HOWARD COUNTY HISTORIC PRESERVATION COMMISSION  
*ELlicott City Historic District ■ LAWYERS HILL Historic District*  
3430 Court House Drive ■ Ellicott City, Maryland 21043

## October Minutes

Thursday, October 5, 2017; 7:00 p.m.

Figure 4 - Site plan showing location of picket fence, iron gate and wooden shed

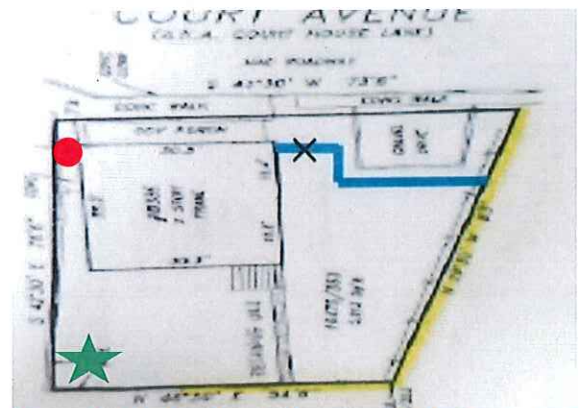
On the other side of the house, as indicated by the red dot in Figure 4, the Applicant proposes to add a 3-foot-tall wrought iron gate in a black matte finish. The gate will be 37 inches from post to post. The application explains that while no gate currently exists, a post hole and wrought iron anchor are visible from a possible previous gate.

The Applicant proposes to install a shed, which will be located in the northeast corner of the yard, as shown by the green star in Figure 4. The proposed shed will be a wood shed, shown in Figure 5, painted to match the existing color scheme of the house: blue siding, white trim, black doors and charcoal asphalt shingles. The shed will sit on a treated wood foundation.

The continuation of the existing white wood picket fence and gate, and the addition of the wrought iron gate complies with Chapter 9.D of the Guidelines, "construct new site features using materials compatible with the setting and with nearby historic structures, particularly for features visible from a public way" and "install open fencing, generally not more than five feet high, of wood or dark metal."

The proposed wooden shed, painted to match the colors on the existing building and located in a corner of the back yard, complies with Chapter 7.C recommendations, "if allowed by the size and shape of the property, place new outbuildings to the side or rear of the main building, separated from the main building by a substantial setback" and "design outbuildings visible from a public way to be compatible in scale, form and detailing with historic structures and outbuildings in the neighborhood." The existing house has a cross gable roof, and the shed mimics this pattern with a front gable roof.

Figure 22 - View of porch looking down Main Street. The red line and paper indicate an approximate two-foot mark.

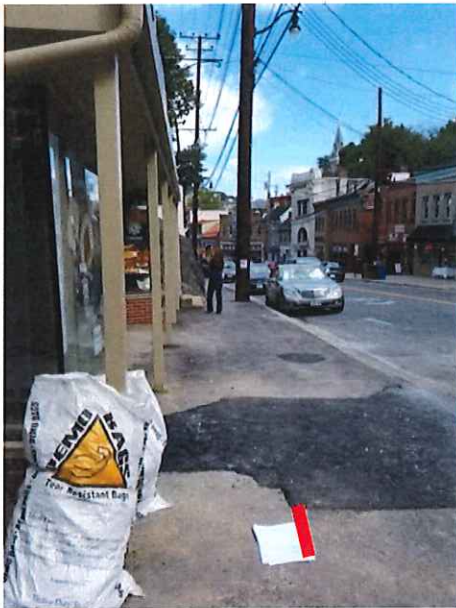
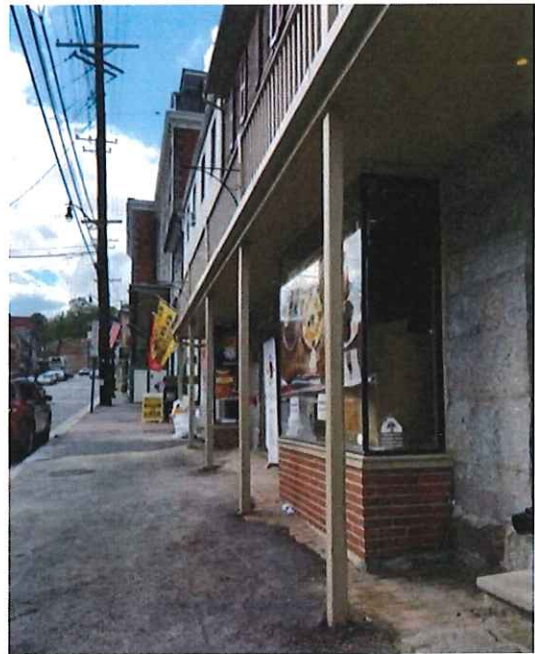
**Staff Comments:** Chapter 6.E of the Guidelines states, "Porches are important to a building's sense of scale. Removing, enclosing or altering a porch can dramatically alter the appearance of a building." Increasing the depth of this porch by two feet would change the appearance of the building. In Figure 22 below, the red line indicates an approximate 2-foot measurement for where the porch would extend over the sidewalk.

The porch and the second floor doors and windows are character defining elements of this building, as this was the primary entrance, so they are more architecturally elaborate than the basement/street level entrances. The Standards state that a property should be used as it was historically and any new uses should require minimal change to the building's distinctive features and spatial relationships, and that changes that create a false sense of historical development should be avoided. While adding two

feet of depth to the porch may not seem like a large change, it will affect the building in several ways. It will be changing the distinctive features of the building and it will be creating a false sense of historical development. This porch was used as a passageway to the doors and was not used for dining. Regarding the changes to the distinctive features of the building, the proposed porch alteration will require a 6-inch increase in the height of the existing railing. The drawings provided in the application, shown in Figure 25, show that the railing would end at the lintel of the second-floor windows. If the drawing is accurate, this would be a perspective that would only be visible from a building across the street on the second floor. When the building is currently viewed from across the street, as shown in Figure 24, the existing railing appears to end just above the window lintel. If this railing is raised 6 inches in height, to 42 inches, and moved two feet further out, it will be blocking substantially more of the windows and doors. Additionally, the view of the second and third floors of the building from the sidewalk below will be blocked by the porch protruding an additional two feet in depth.

Figure 25 - Front elevation showing proposed alterations

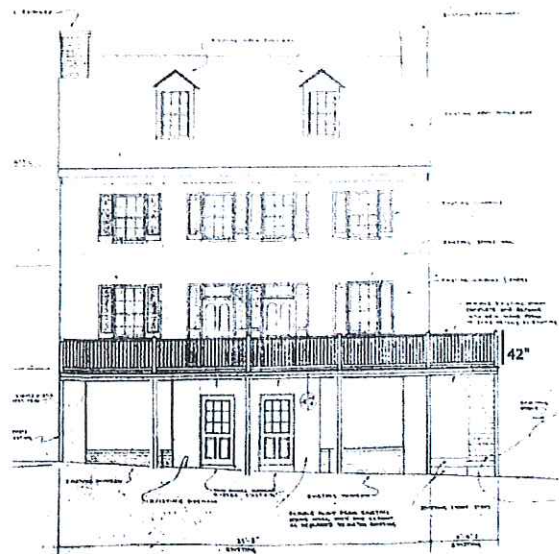
Standard #1 states that a property shall be given a new use that requires minimal change to its distinctive features. This Standard exists because if a building was continuously changed for each tenant that resided in it over the years, it would eventually lose all historic integrity. The Applicant intends to put outdoor tables and chairs on the porch for dining purposes and historically the porch was not constructed for that purpose. Aside from the higher railing that is required, tables and chairs would also clutter the view of this historic building and there is always the possibility that the Applicant could add umbrellas, further altering the view.

Chapter 7 provides recommendations on 'New Construction: Additions and Porches' and is relevant to this proposal since the Applicant proposes to add depth to the front porch. Chapter 7 recommends, "design and fit additions to avoid damaging or obscuring key architectural features of a historic building" and "attach additions to the side or rear of a historic building to avoid altering the primary façade." Staff finds the proposal would alter and obscure the key architectural features on the primary façade. Chapter 7 also states, "decks...should be substantial in appearance, having more of the character of a porch (avoid decks that appear to stand on toothpicks)." By adding to the depth of the existing narrow porch, the proposal will not comply with this Guideline and the increased scale and massing of the porch will appear to stand on toothpicks, as the posts on this building are tall and narrow.
